Chip Errata for the i.MX27

Silicon Revision: 2.0, 2.1, and 2.2

This document details all known silicon errata for the i.MX27. [Table 1](#) provides a revision history for this document.

Figure 1. Recommended Power-Up Sequence

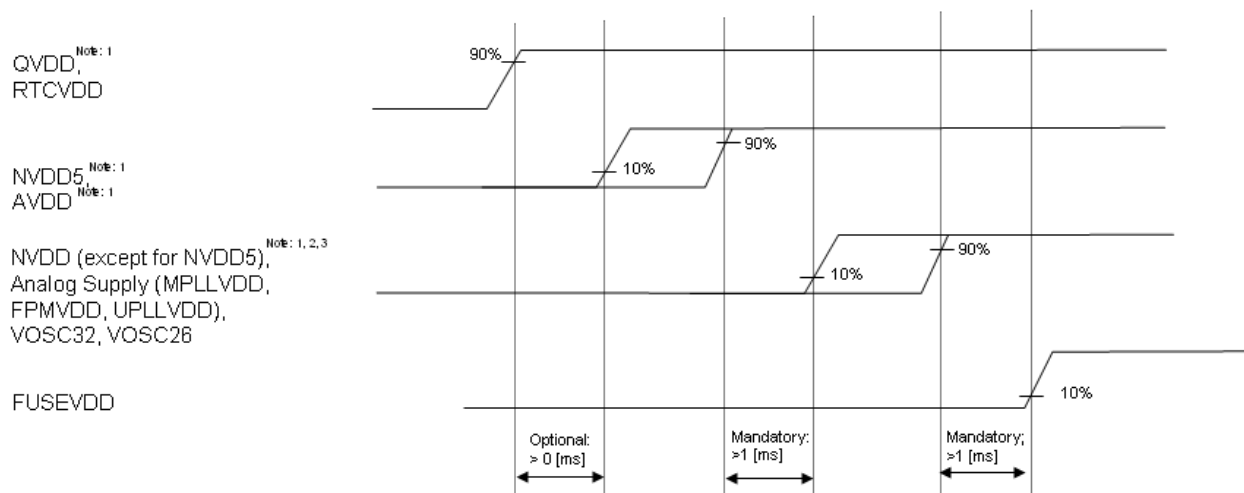
(Continued from erratum 10, ID ENGcm11563)

- 1 QVDD, AVDD (IO power for BOOT pin), NVDD5 (IO power for POR_B pin) must be powered up before MPLLVDD.
- 2 MPLLVDD must be driven to 0, not floating, before powering up.
- 3 NVDD supply domain (except for NVDD5) can be turned on either at the same time as MPLLVDD or with NVDD5

Figure 2. Recommended Hardware Fix if QVDD and MPLLVDD are Ganged

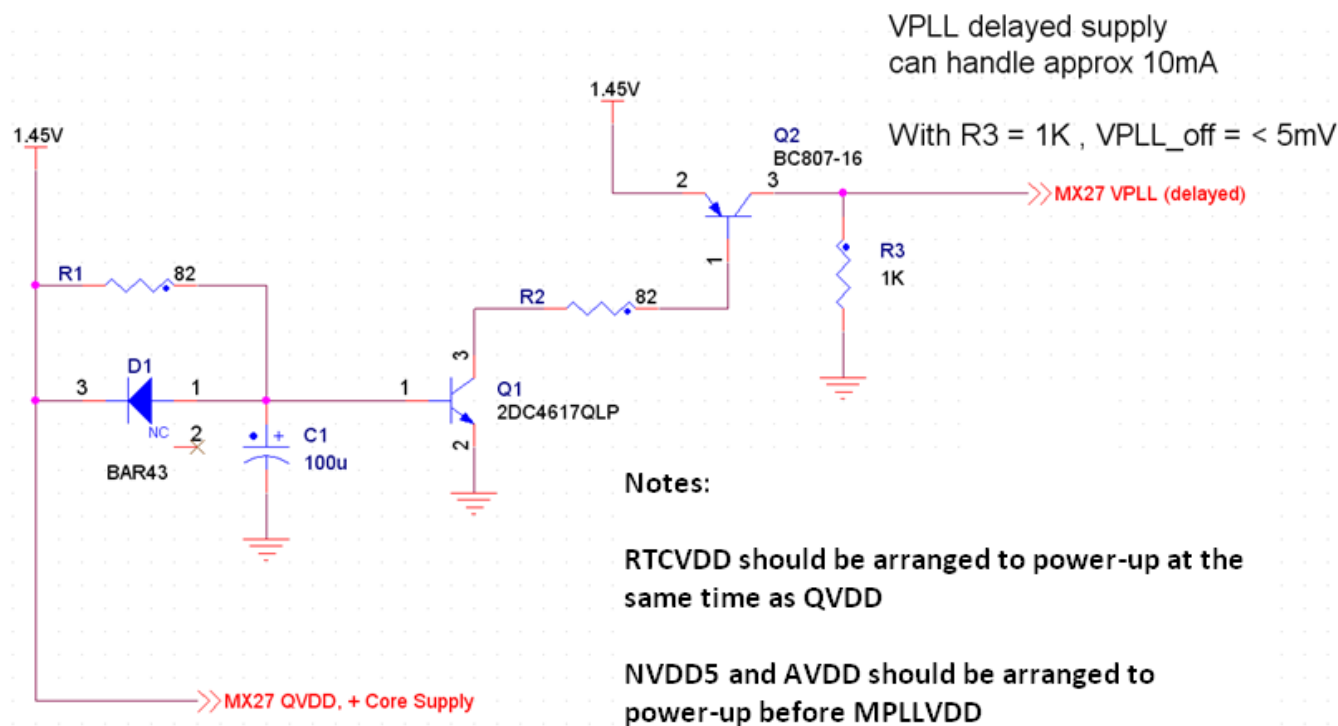
Number	Severity	Erratum ID	Summary	Details
10	2	ENGcm11563	<p>Module Affected: PLL</p> <p>Title: Boot problem due to improper clock duty cycle</p> <p>Note: Systems that use 266 MHz are not affected by this bug.</p>	<p>Description: There is a design errata in the i.MX27 PLL/DIV design, which causes the ARM_CLK to have an incorrect duty cycle. The root cause of this issue is due to an uninitialized node in the PLL, clock gating, and divider circuitry, so the probability of this issue is random. This error causes the ARM™ and DDR clocks duty cycle to be 66% when they are running at 266 MHz and 75% when at 399 MHz, instead of 50%.</p> <p>Projected Impact: The result of the incorrect duty cycle of the clock is that the ARM core might halt. This issue affects systems that enable 399 MHz for the ARM core.</p> <p>Workarounds: There are both a hardware and a software workaround. To guarantee correct operation, the software workaround should only be applied to devices that have had the new PLL test applied. The test will be applied from a date code 1105:</p> <ul style="list-style-type: none"> • Workaround 1—Hardware: Keep MPLLVDV < 200 mV during the initial part of the power-up sequence and delay the MPLLVDV supply with respect to QVDD, NVDD5, and AVDD. See Figure 1 for a recommended power-up sequence. This workaround sets the uninitialized node to the correct state enabling the appropriate 399 MHz clock output duty cycle. For the clock switching errata workaround, the following conditions must be satisfied: <ul style="list-style-type: none"> – QVDD must be powered up before MPLLVDV. – NVCC5 must be powered up before MPLLVDV. (This is required for the POR_B signal to propagate to the clock gating logic.) – AVDD must be powered up before MPLLVDV. (This is required for the POR_B signal to propagate to the clock gating logic.) – MPLLVDV must be driven to 0, not floating, before powering up A suggested delay circuit is described in Figure 2. • Workaround 2—Software: Originally for the ARM clock to work at 400 MHz, the MPLL is configured for 800-MHz operating frequency at the 2x Clock Port (see Figure 3 and code that follows the figure), and the DIV2 divider is selected by software to achieve the 400-MHz operating frequency at the ARM core. The default 266-MHz frequency is achieved by using the DIV3 divider with an 800-MHz frequency at the 2x Clock Port (so 400-MHz MPLL frequency). The intent of this workaround is to reconfigure the 2x Clock Port to 1.2 GHz (600-MHz MPLL frequency), and continue to use the DIV3 divider in order to achieve the 400-MHz operating frequency. This avoids switching to the DIV2 divider, which introduced the problem. <p>Fix Plan/Status: No fix planned. <i>See continuation of this erratum on p. 12.</i></p>

Figure 3. i.MX27 Clock Architecture

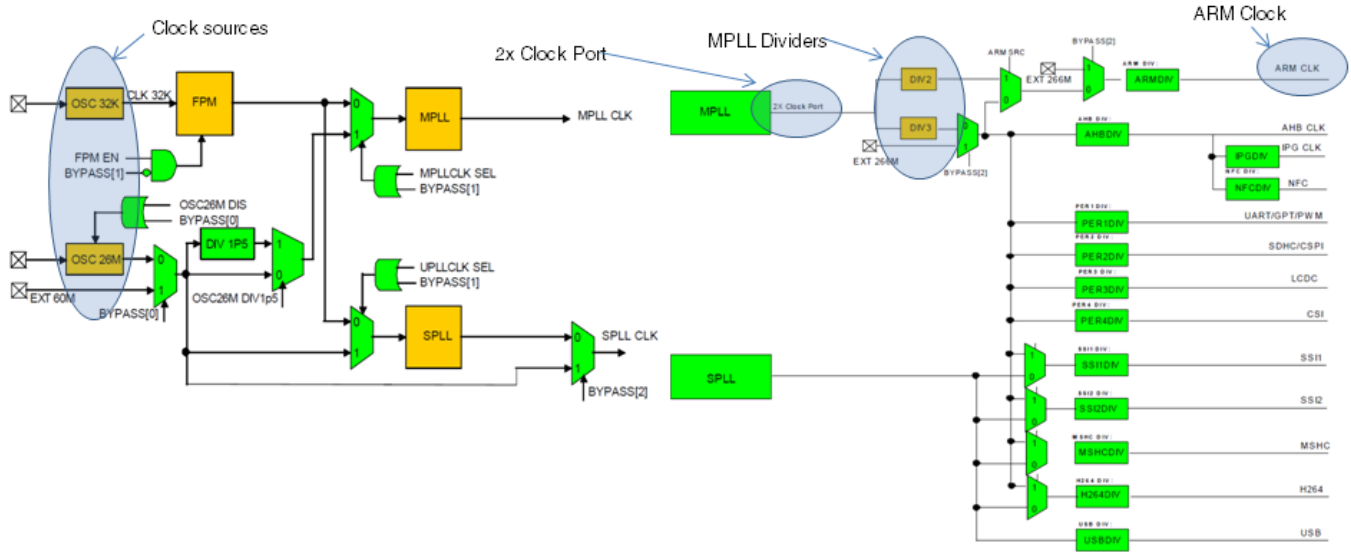
See the code following this figure.

The following code provides guidance for setting the MPLL to the new setting (600 MHz) that equates to an output of 1.2 GHz at the 2x Clock Port.

Finally, the 1.2GHz is programmed at the 2x Clock Port and the MPLL is restarted for the ARM to start running at 400MHz
